Technical Service Bulletin

19 Thermostat, electric fault (DTC P0599, P0597, P2181)

19 16 68 2042328/2 March 9, 2016. Supersedes Technical Service Bulletin Group 19 number 15-63 dated October 29, 2015 for reasons listed below.

Figure 2. Coolant thermostat housing for map-controlled engine cooling.

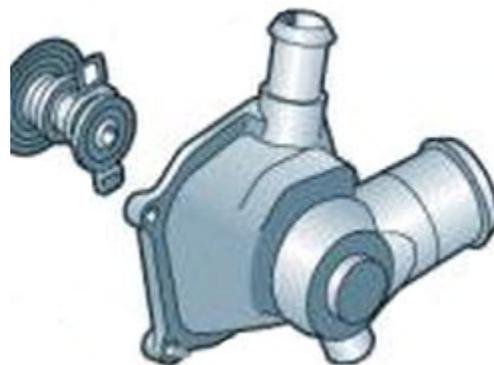
If one of the DTCs listed in the *Condition* is stored, replace the coolant thermostat housing for map-controlled engine cooling (Figure 2).

It is not necessary to replace the complete coolant pump.
